Subject: Racine Hydroelectric Project (FERC No. 2570) -- Filing of Initial Study Report Meeting Summary

RE: Racine Hydroelectric Project (FERC No. 2570); Initial Study Report (ISR) Meeting
Summary Disagreements and Requests to Amend Study Plan to Include New or Modified
Studies

Subject: FW: Racine Hydroelectric Project (FERC No. 2570) -- Response to Initial Study Report Comments

Figure 1. Total Racine Dam Tainter Gate Opening, and Tailwater Elevation, April 1-May 31, 2020.

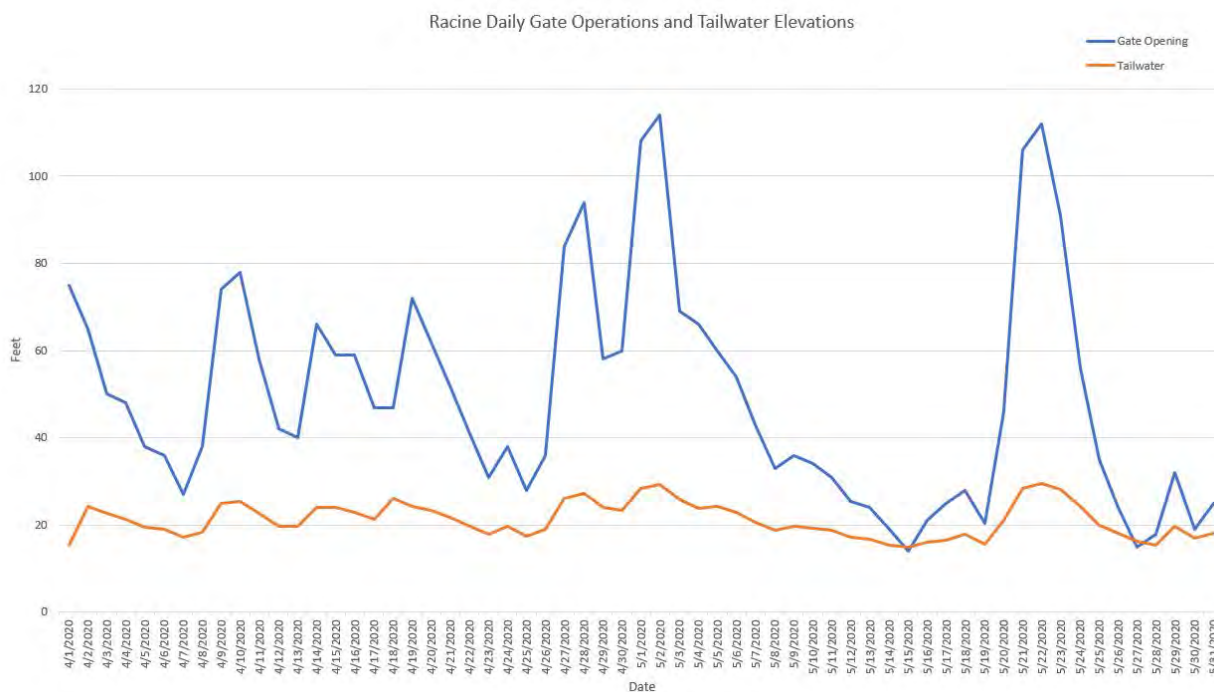
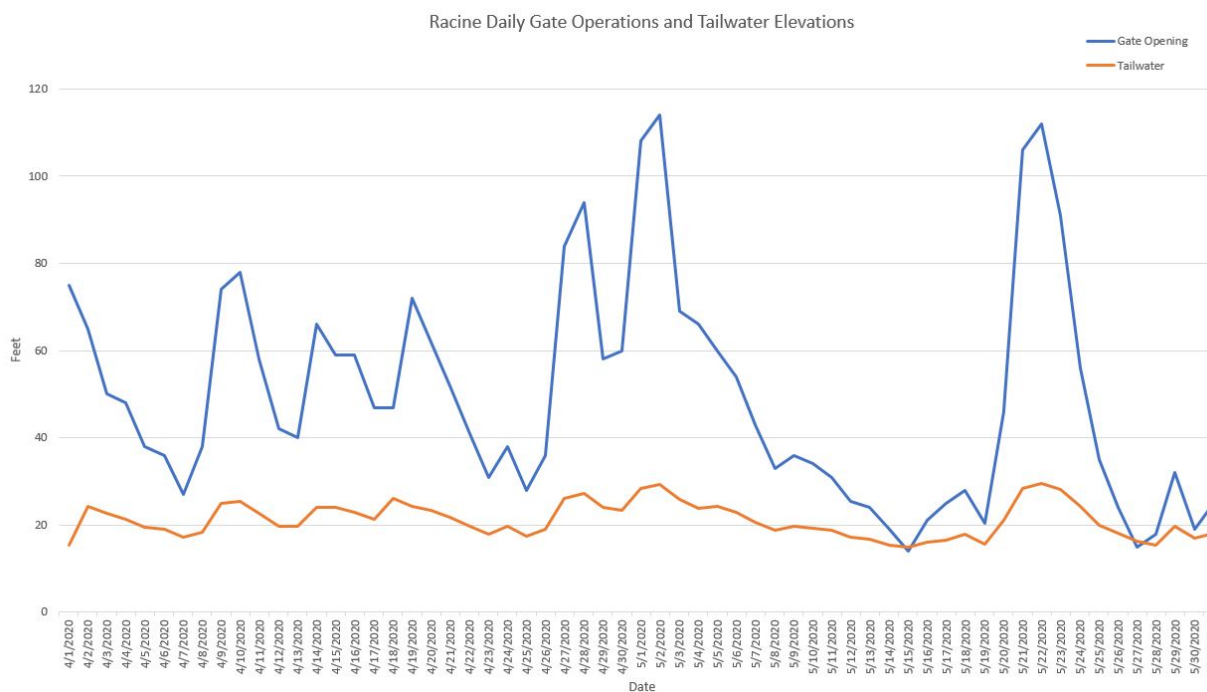
USR Status and Summaries of Studies, 2.5.2, Fisheries Surveys, Summary of Study

Methods and Results, bottom of page 10: It is understandable that COVID-19 restrictions prevented surveying prior to the end of May 2020; however, the Service questions the statement that high flows also contributed to the late start. Based on dam Tainter gate opening and tailwater elevation data for the months of April and May (Figure 1), it appears there were other windows prior to the end of May when river flow was low and the surveys could have been completed. According to the U.S. Army Corps of Engineers (USACE; Corps), the total gate opening (i.e., across all Tainter gates) is the variable that they track for correlation with river flow (i.e., greater total gate opening = more spill associated with higher river flow). For example, on May 22, 2020, the total gate opening was 112 feet, corresponding with a high flow event, and tailwater was also elevated, whereas, at the time of the fisheries surveys on May 27 and May 28, total gate opening ranged between 15 and 27 feet, and the tailwater elevation was lower, reflecting lower flow conditions more conducive to conducting the surveys. During the period May 14-19, when it appears there was an earlier opportunity to conduct the surveys due to low flow conditions, the total gate opening ranged between 14 and 28 feet. As illustrated in Figure 1, there were additional opportunities, prior to the end of May, when the fisheries surveys could have been completed, so high flow should not have been cited as a contributing factor.

EnviroScience's 2020 spring fisheries surveys in support of the Racine Project relicensing were conducted on May 27 and 28, when total gate opening and tailwater were low, reflecting a low amount of spill corresponding with relatively low river flow. Tailwater elevation is represented by the lower gage reading (e.g., a gage reading of 20 feet = a Tailwater elevation of 546 ft msl).

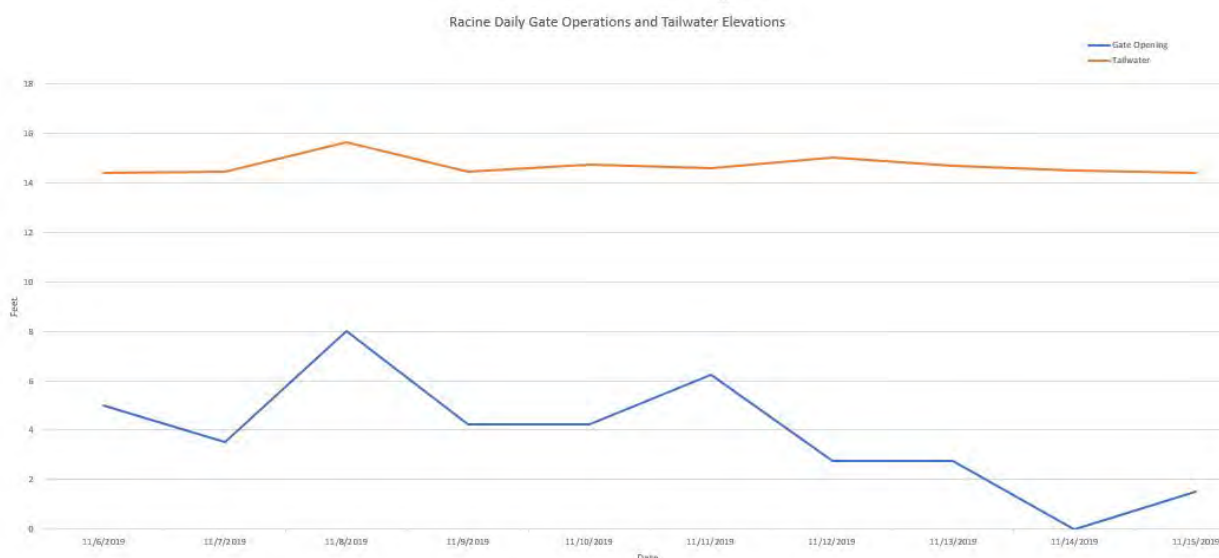
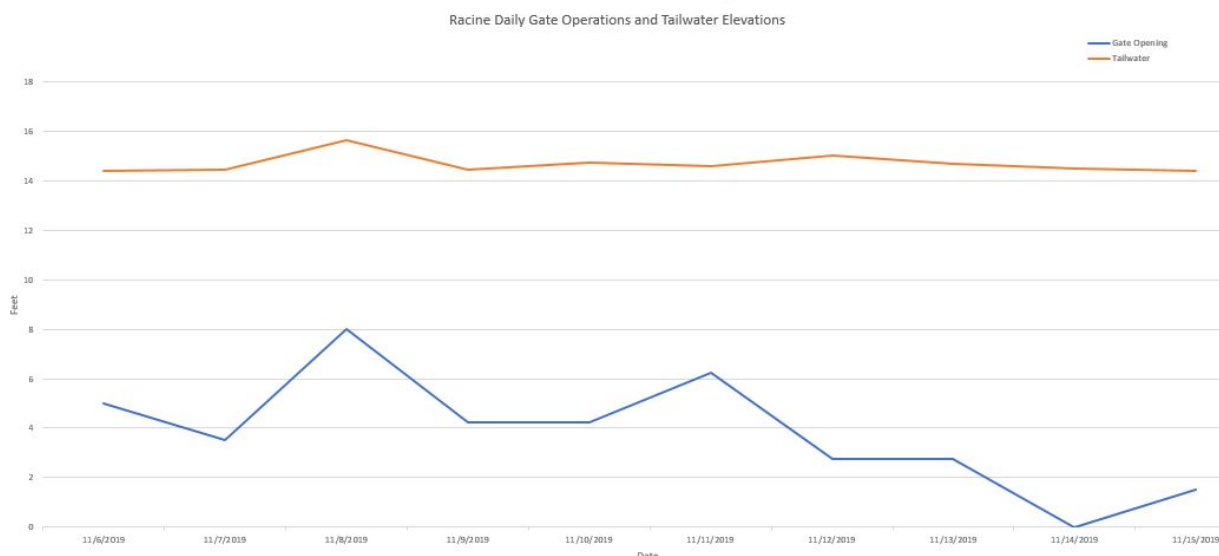
According to the SPD, at a minimum, downstream electrofishing targeting American eel was to be conducted during evening/night-time hours, after periods of elevated river discharge, to coincide with periods of peak upstream eel migration. The spring electrofishing surveys were conducted May 27-28, 2020. The surveys were conducted at night, beginning just after dusk, in conformance with the SPD. In addition, these surveys were conducted following a period of elevated river discharge (Figure 1), also in conformance with the SPD. The fall electrofishing surveys downstream of the Project were conducted November 11-13, 2019. These surveys were also conducted at night. However, there was no period of elevated river discharge prior to the

conduct of the fall electrofishing surveys. Over a 5-day span preceding the fall surveys, the tailwater elevation remained below 542 feet (lower gage reading < 16 ft), and the total gate opening did not exceed 8 feet (Figure 2), indicating there was no period of elevated discharge immediately preceding the fall surveys. The SPD also specified that the study should include a spring, summer, and fall American eel-targeted electrofishing survey (as site safety conditions allow). The downstream electrofishing surveys covered only two short time periods and were not American eel-targeted surveys, although the surveys were conducted along both shorelines.

Figure 2. Illustration of a Tainter gate at the Sauveterre Dam, Rhone, France, similar to those at Racine, with submerged sill (credit: Christophe Peteuil).

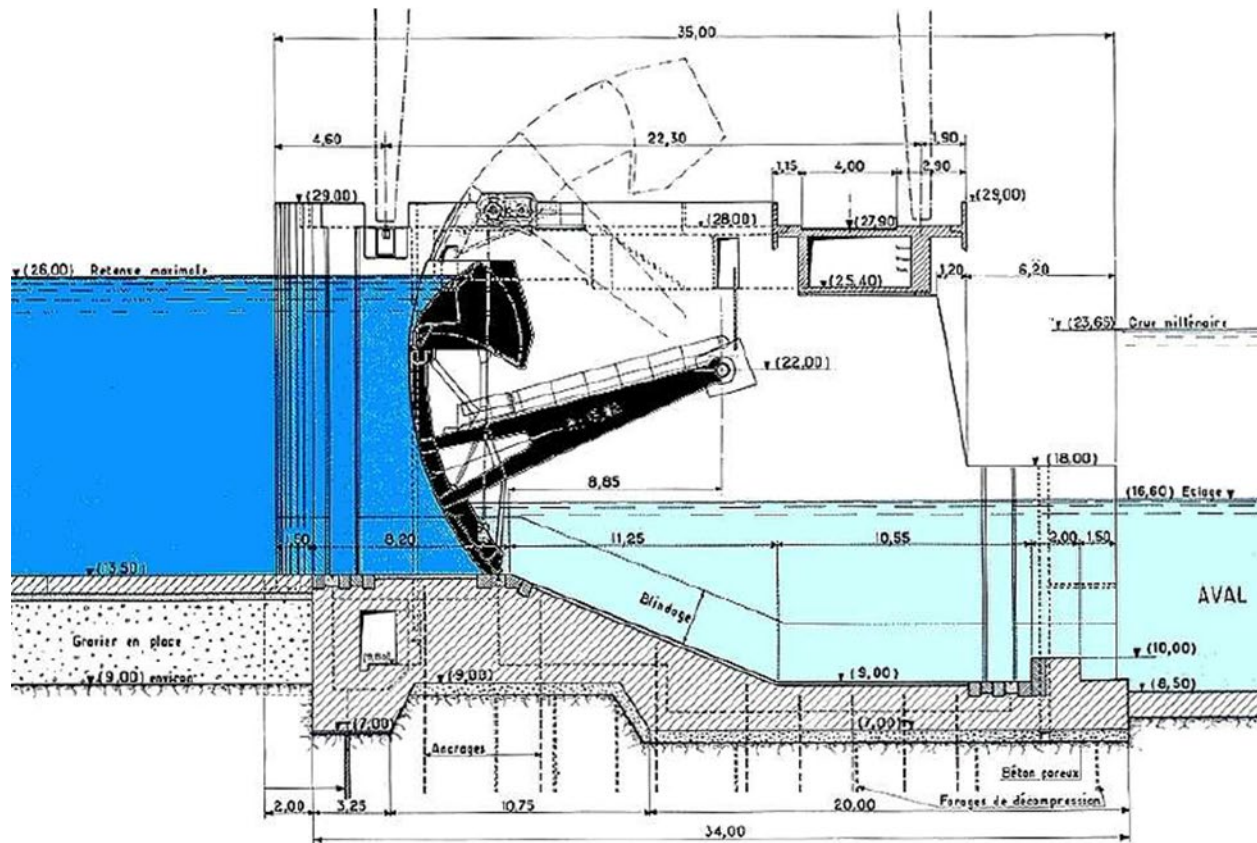
Similar to a Tainter gate at the Racine Project, Figure 2 depicts a Tainter gate with a well-submerged sill.

Figure 3. 2016 Total Tainter Gate Opening (blue) and Number of Units Operating (orange)

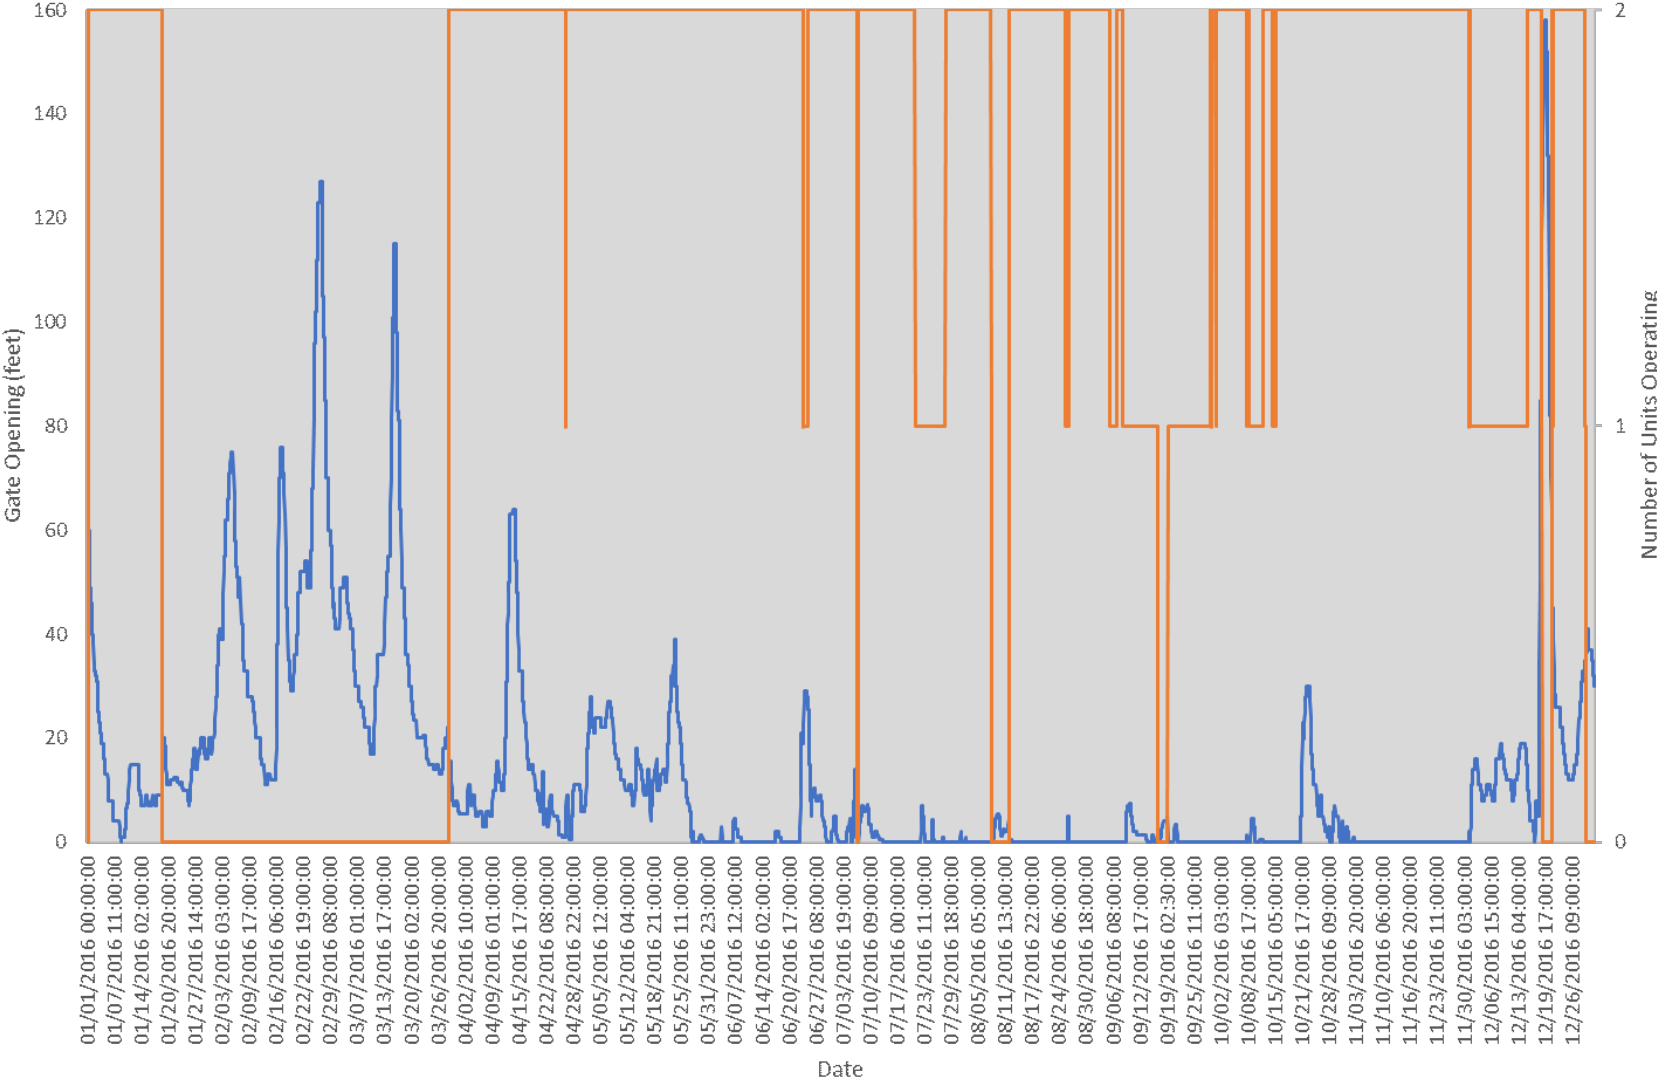
During 2016, river flows were below Project hydraulic capacity 0.5 percent of the time, within hydraulic capacity 42.6 percent of the time, above hydraulic capacity but within the Project's operating range 53 percent of the time, and above the Project's operating range 3.0 percent of the time (Table 4). Therefore, river flows were within the Project's operating range more than 95 percent of the time, but more than half of that time was above hydraulic capacity, resulting in the need to release excess flow through one or more of the Tainter gates (Figure 3).

Figure 4. April – June 2016 Total Tainter Gate Opening (blue) and Number of Units Operating (orange)

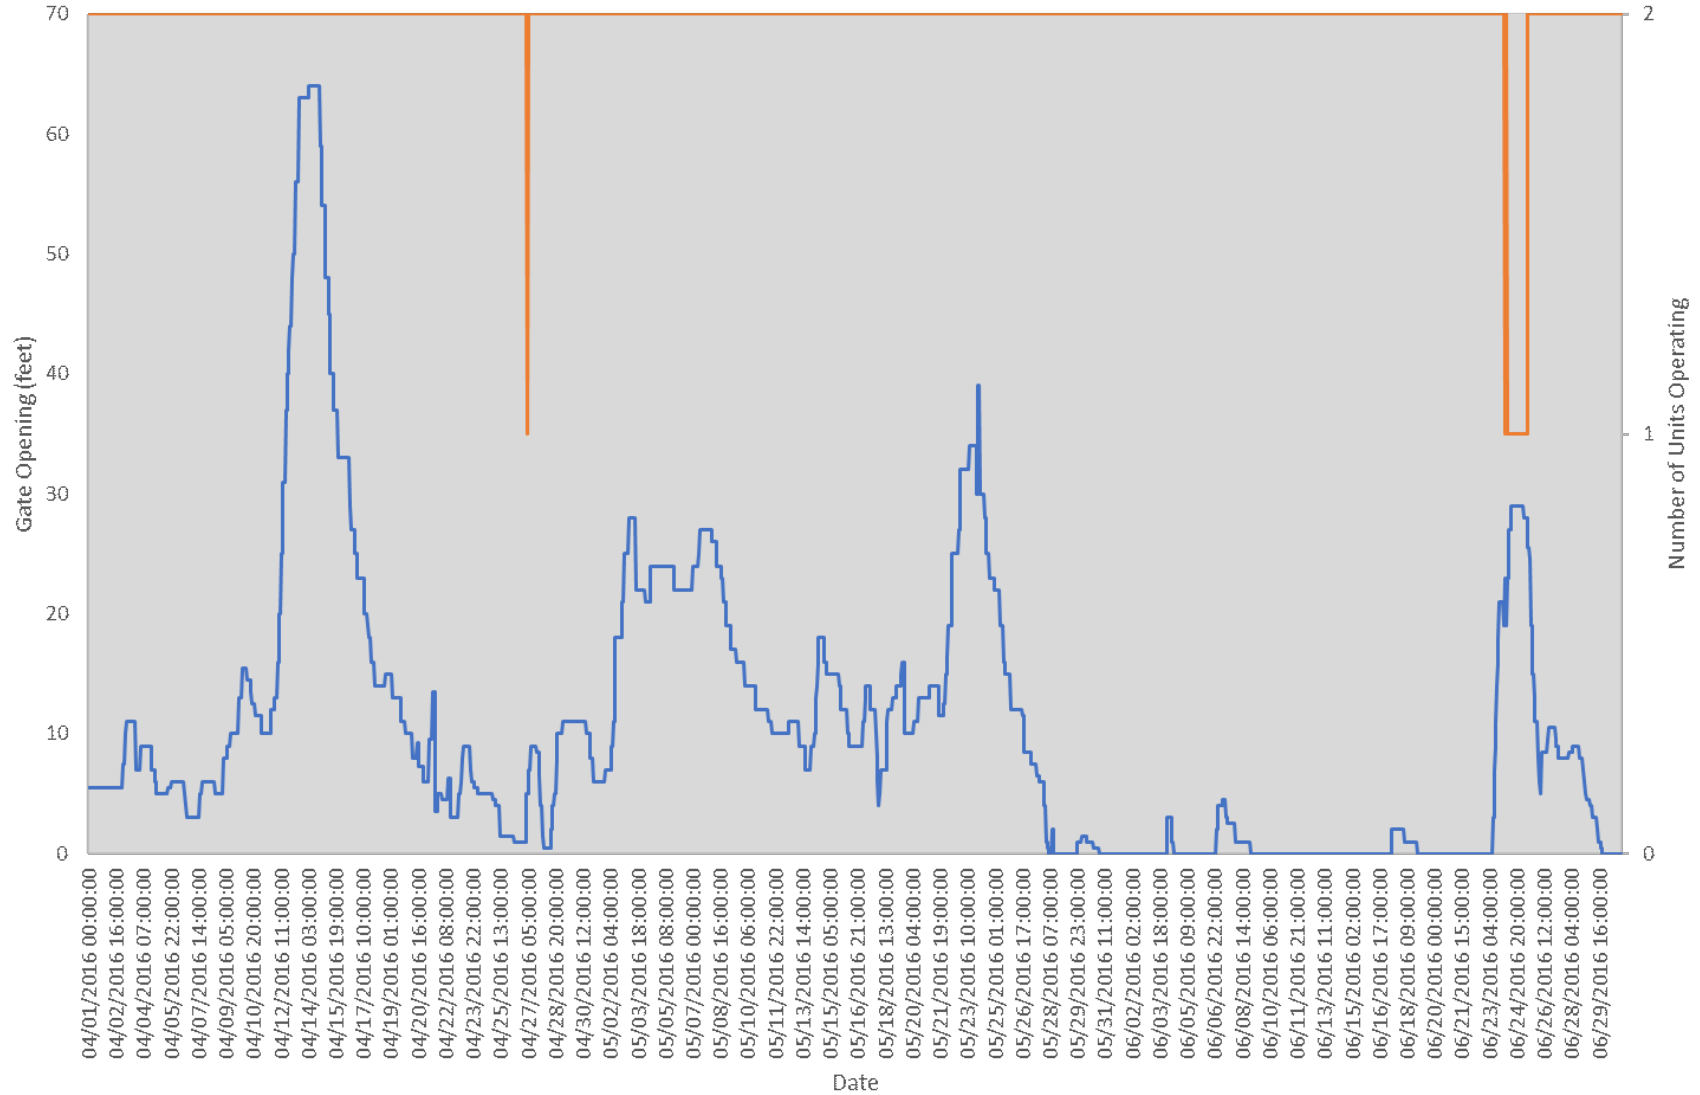
During the key period of April through June of 2016 (sauger and skipjack herring spawning and highest expected sauger entrainment rates), there were no days when the Project did not generate (Table 5 and Figure 4). During April, there were no periods of generation with no Tainter gate opening (i.e., there was presumably an alternative to the powerhouse available for downstream fish passage; Table 6). This was mostly the case during May 2016, when no gate opening was available only 8 percent of the time. However, in the key month of June, all Tainter gates were closed 65 percent of the time, during which there was no alternative to the powerhouse, aside from the locks, for downstream passage. It is important to note that when all gates are closed, fish moving downstream will likely be attracted to the powerhouse side of the river (i.e., away

Figure 5. July – August 2016 Total Tainter Gate Opening (blue) and Number of Units Operating (orange)

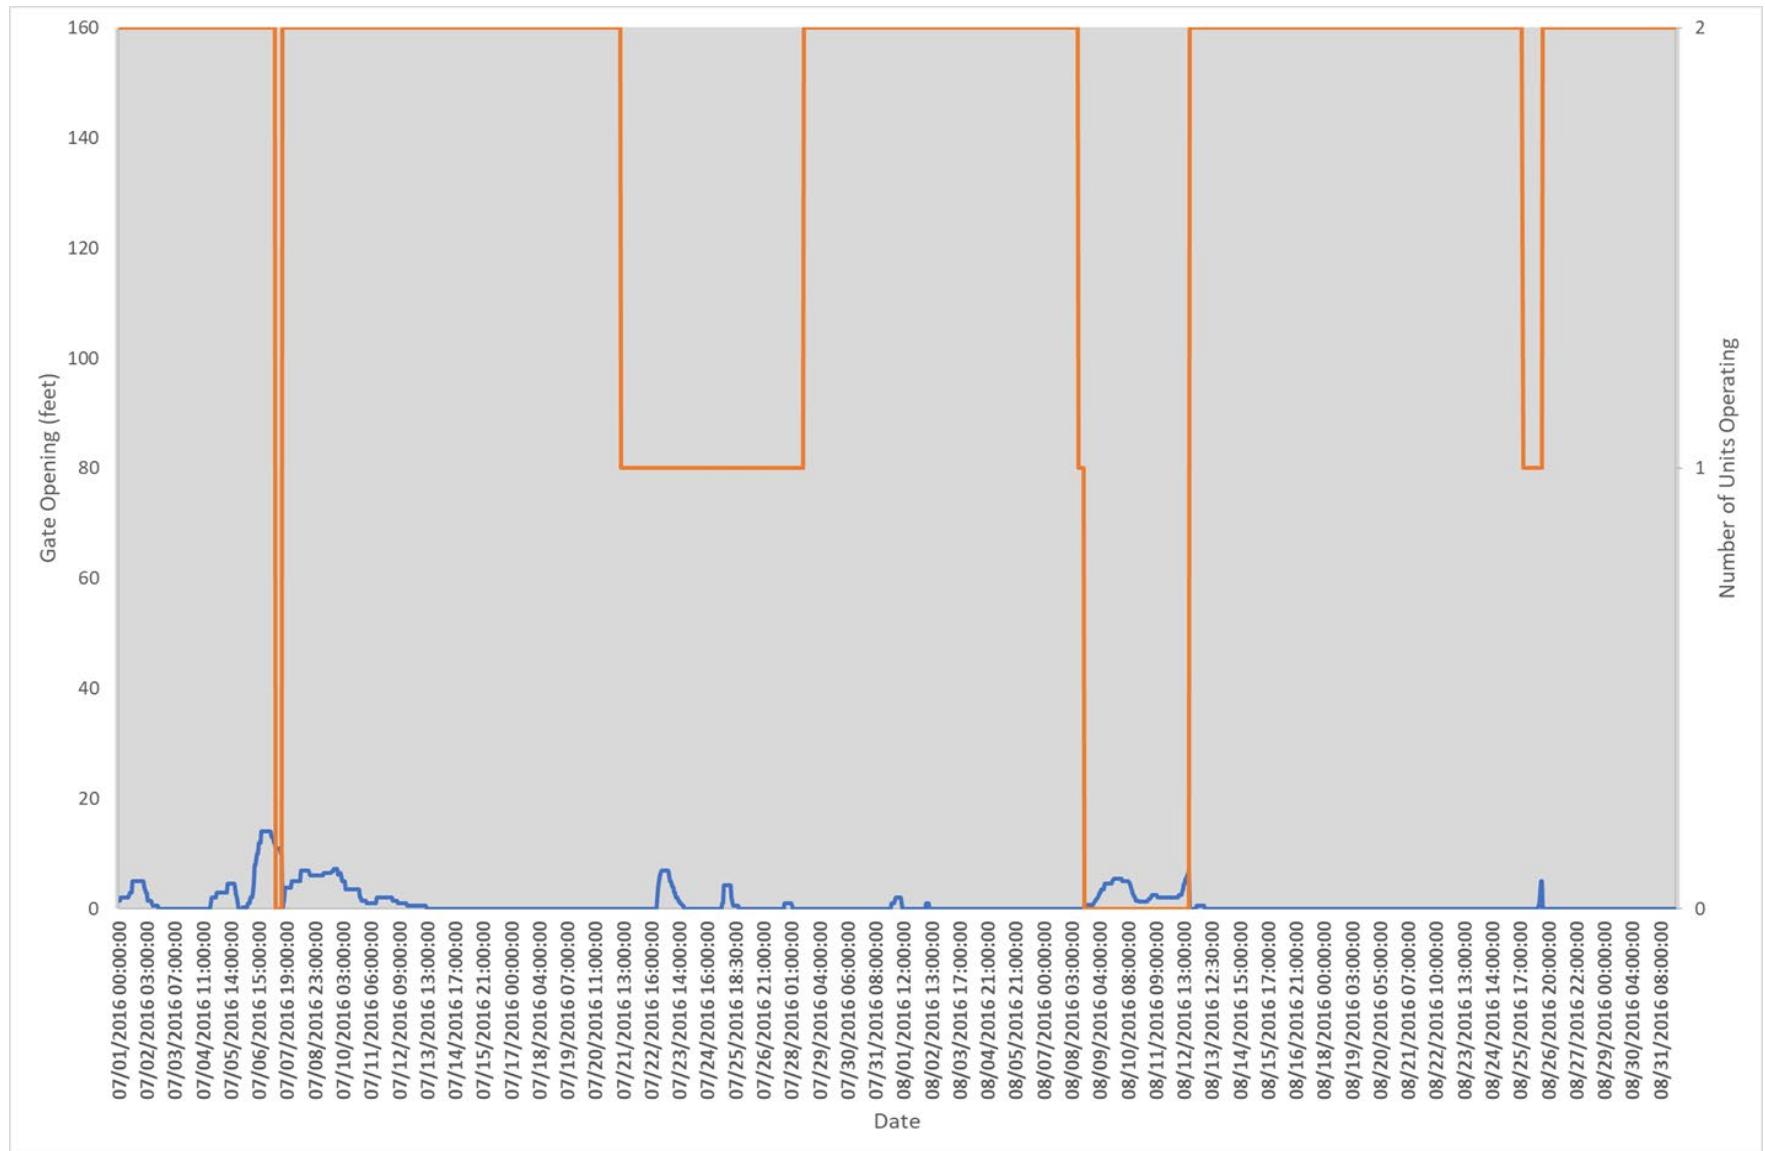
During July through August, 2016 (post-spawn downstream migration of adult skipjack herring, and smaller sauger entrainment peak), the Project was generating on most days (Table 5), but all gates were closed 61 percent of the time in July and 83 percent of the time in August (Table 6 and Figure 5), indicating high potential for entrainment during those months. From the beginning of September through December (YOY skipjack herring downstream migration, additional smaller entrainment peaks for sauger, and likely downstream migration period for adult silver-phase American eel), the Project was again generating on most days (Table 5), but, except for during December, gates were closed much of the time, especially in November when all gates were closed 96 percent of the time (Table 6 and Figure 6). This is a significant concern to the Service, as this period likely coincides with silver phase American eel out-migration.
